Maryland Zoo in Baltimore Chesapeake Flyway
Responses to Bidder Questions and Written Identification of Modifications to Project Documents

BULLETIN NO. 1

TO: BKP
ATTN: Crystal Collado
PROJECT: Chesapeake Flyway
PROJECT NO : 11045
CHANGE BULLETIN NO. : CB-1 DATE: October 1, 2026
COORDINATE WITH CB NO. : None PREPARED BY: Stephen Jones
Bobby Biddinger

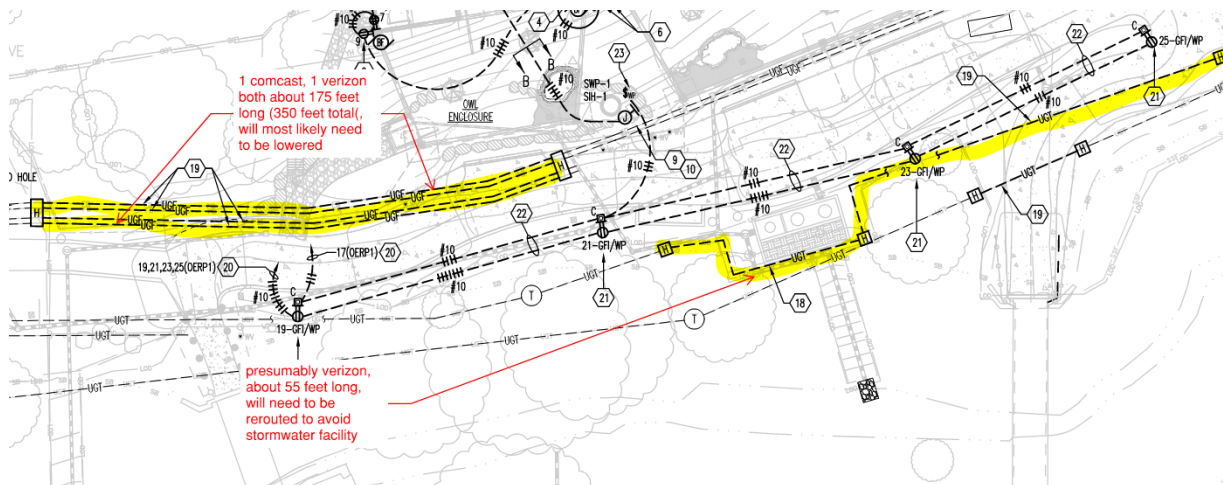
21. Detail H1/A120 indicates steel across the top of the catchboxes for netting attachment however the structural drawings do not indicate how the steel is to be attached. Please provide structural details for this attachment and at the vestibules.

Response: Steel header at catchboxes are 6"x4"x3/8" and vertical post is 4"x4"x3/8". See detail A5/S531 for HSS to HSS welding requirements.

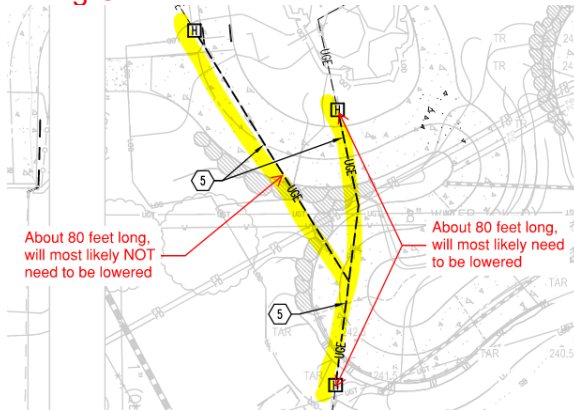
24. Will the tele/data cables be removed and reinstalled by others? Typically, they are not spliced. The handholes will need to be sized off number and size of conduits entering and leaving.

Response: Verizon to reroute their telephone lines. GC to provide conduit and coordinate with the owner and Verizon as soon as possible. Existing conditions unknown. Construction sketches to be provided as needed after existing conditions are identified by the GC during CA.

M101

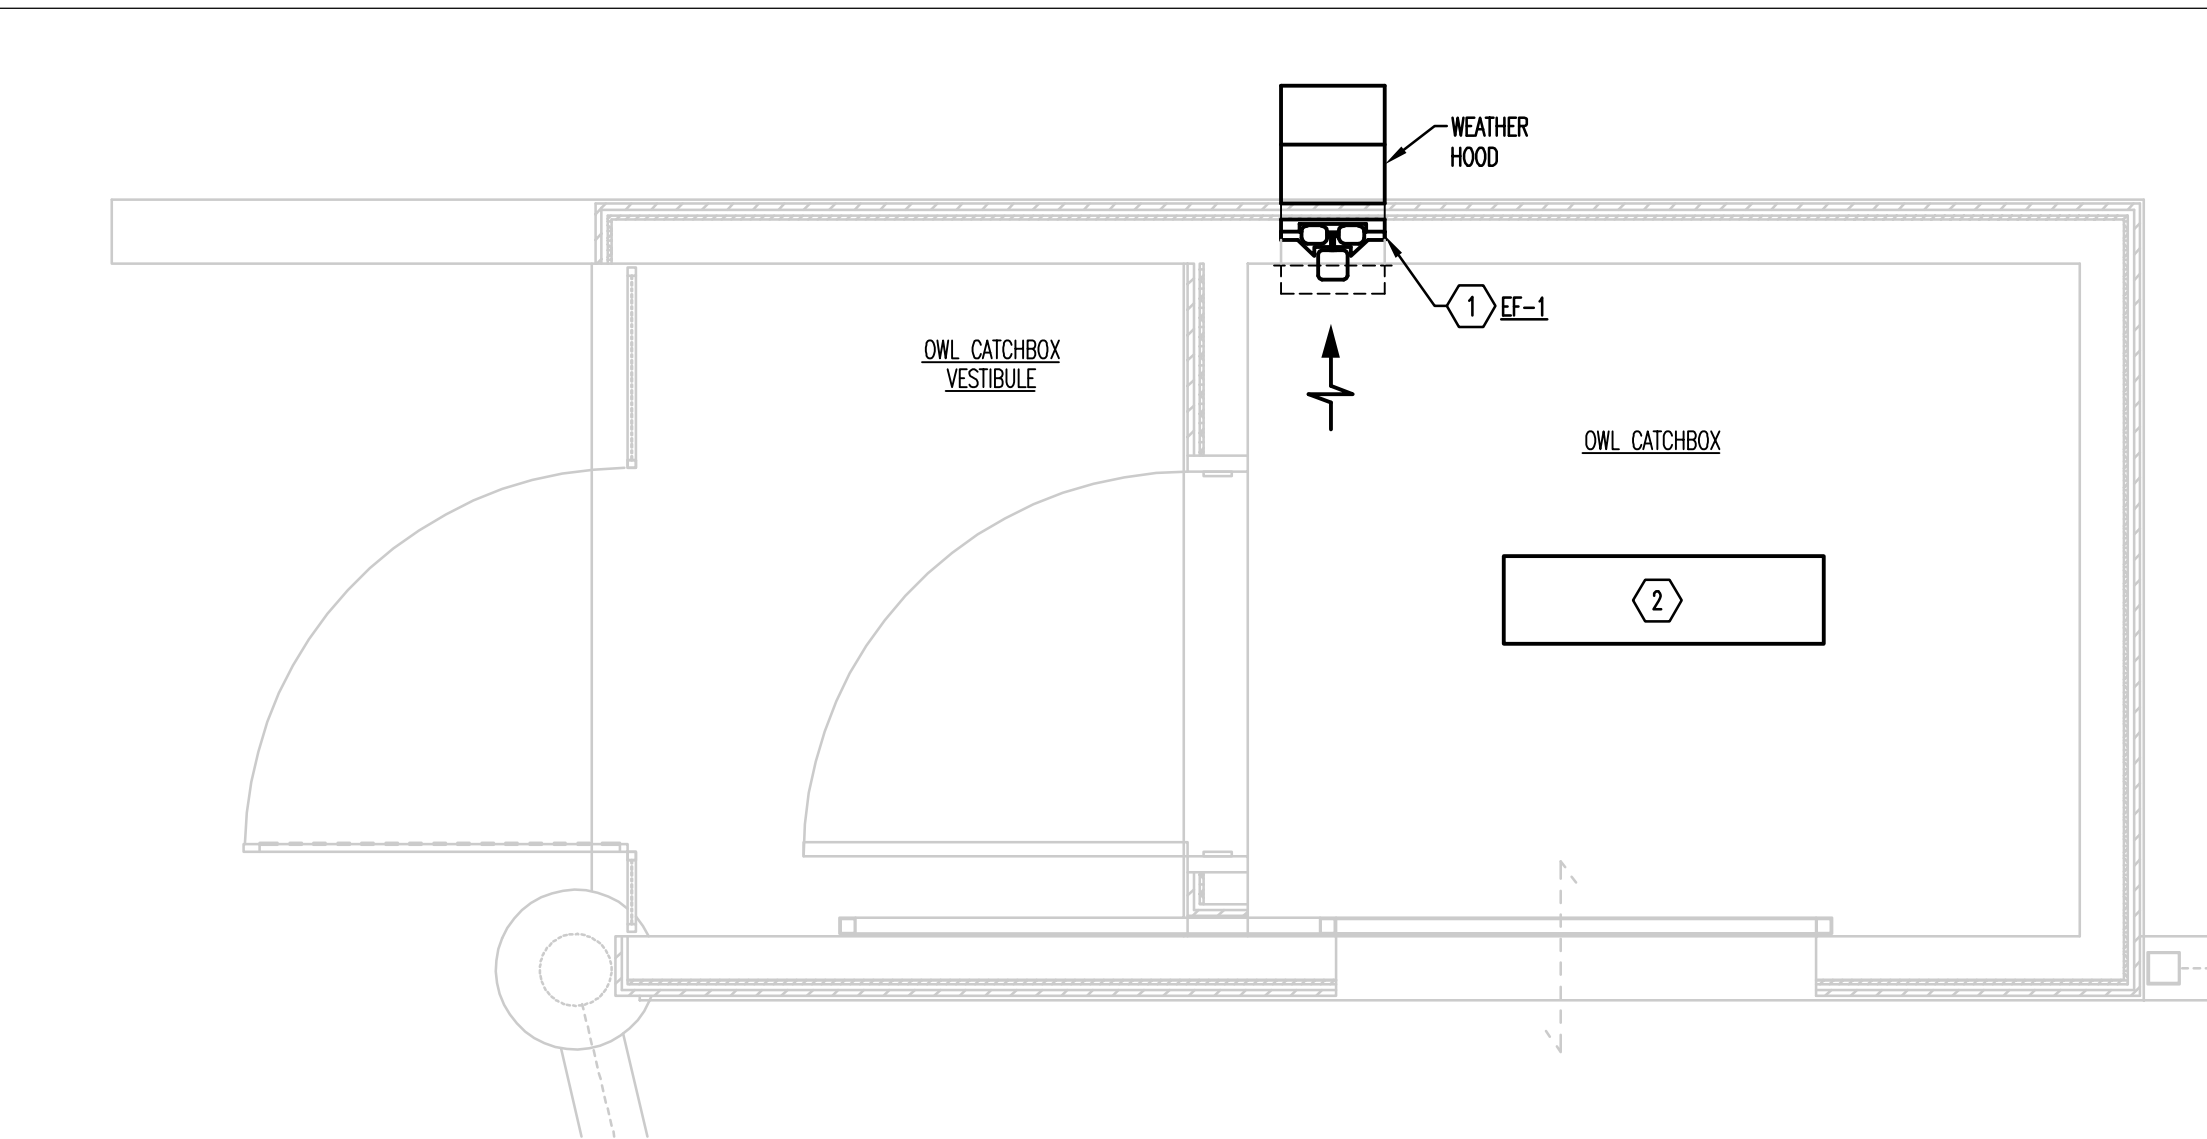
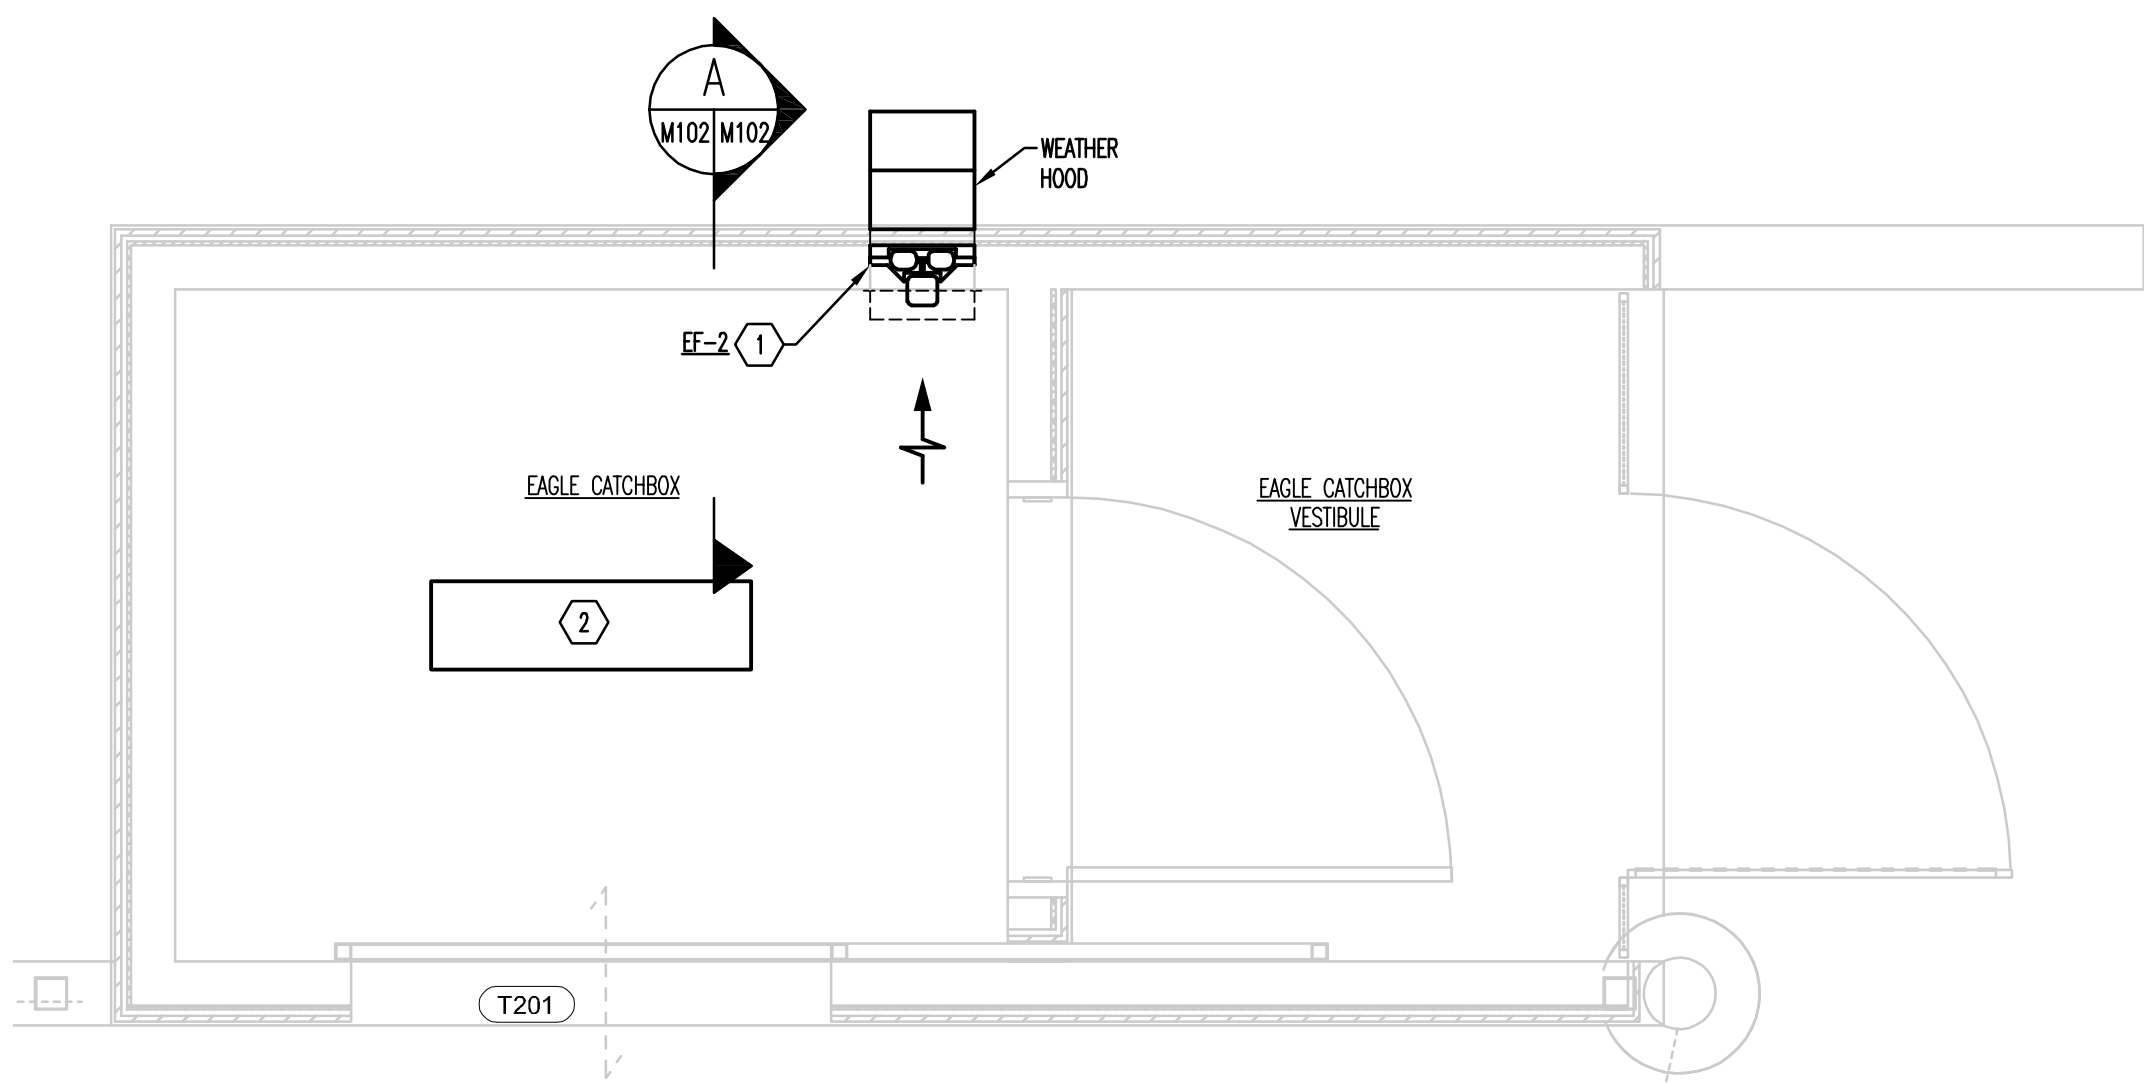
1. Drawing M101
 - a. Added new sump pump, controls and cabling to existing sump pump system in the Caves exhibit.
 - b. Revised drawing note 5 and added drawing notes 15 and 16.
2. Drawing M102
 - a. Revised Sewage Waste Sump Pump Schedule.
3. Drawing E101
 - a. Added demolition of existing sump pump controllers and associated branch circuit wiring.
 - b. Added new duplex sump control panel, buck/boost transformer, and interconnecting wiring in Caves.
 - c. Added drawing notes 24-28.
4. Drawing E601
 - a. New Panel A Schedule; added new 2P-25A circuit breaker in positions 37/39 for connection of CSP-1 branch circuit wiring.
 - b. New Panel OERP1 Schedule; revised circuit breaker trip rating for branch circuit #16 to be 15A in lieu of 20A to coordinate with reduced HP sump pump motor.
